Date: December 15, 2022
RFB No: 2022-095
Commodity: Zoo HVAC Replacement

Addendum No: 1

RFB 2022-095 Zoo HVAC Replacement - ADDENDUM 1

HVAC equipment replacement
project for:
BRAZOS RIVER COUNTRY
CAMERON PARK ZOO
1701 N. 4th St.
WACO, TX 76707

M8

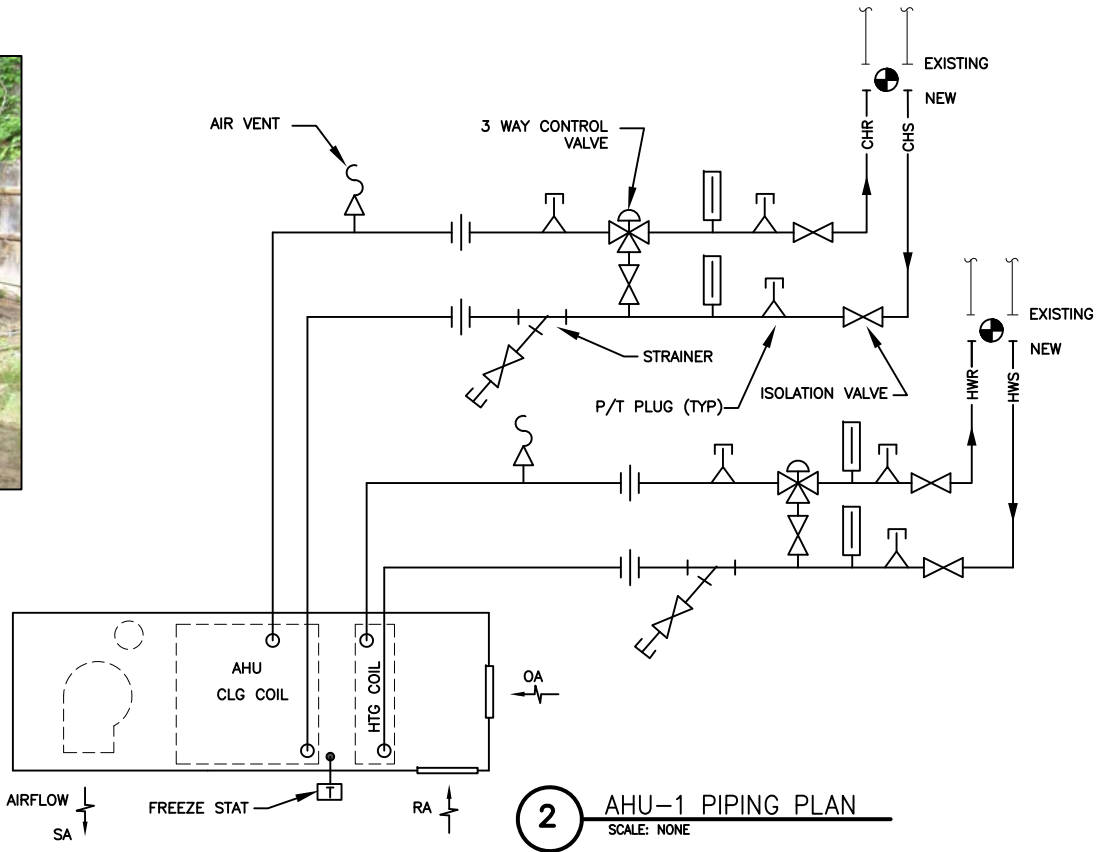
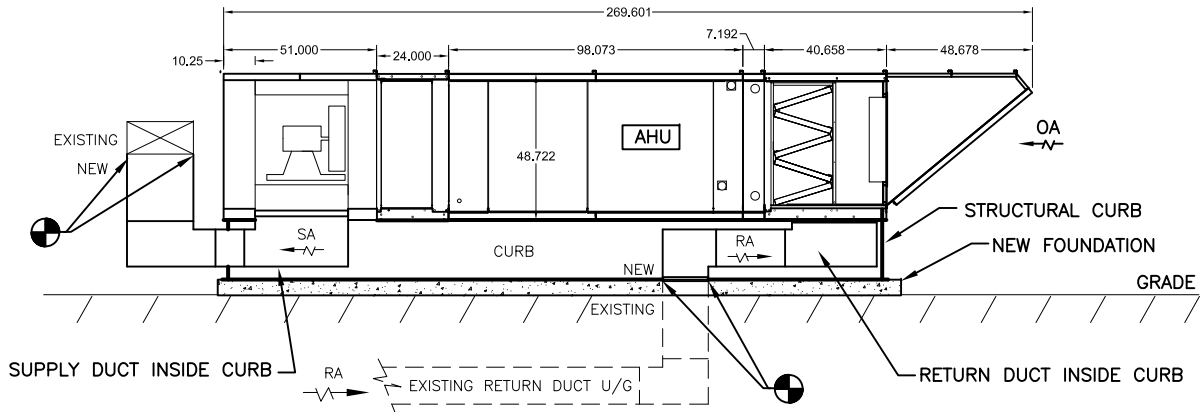
- INCLUDE ADD ALTERNATE BID. REFERENCE DRAWING SHEETS M8, E8
- REVISED BID FORM
- CONTRACTORS BE SURE TO BID TO ADDENDUM 1 BID SHEET
- 90 CALENDAR DAY PROJECT TIME WILL BEGIN AFTER DELIVERY OF EQUIPMENT

EXISTING AHU IS ABOUT 20 YEARS OLD, IS WORN OUT, AND REQUIRES REPLACEMENT. PURPOSE OF THIS WORK IS TO REPLACE EXISTING AHU WITH A NEW CHW/HW AHU.

- DISCONNECT ALL PIPING & ELECTRICAL CONNECTIONS.
- REMOVE EXISTING AHU AND BASE, AND DISPOSE OF PER OWNER REQUIREMENTS.
- INSTALL NEW AHU AND BASE PER DETAILS & MANUFACTURER'S GUIDELINES.
- RE-CONNECT DUCTWORK & PIPING.
- REF. E8 PLAN FOR ELECT WORK.
- CONTRACTOR SHALL INSPECT AND RE-USE EXISTING PIPING AS IS MOST PRACTICAL. REPLACE WITH NEW TO MATCH EXISTING AS MAY BE REQUIRED.
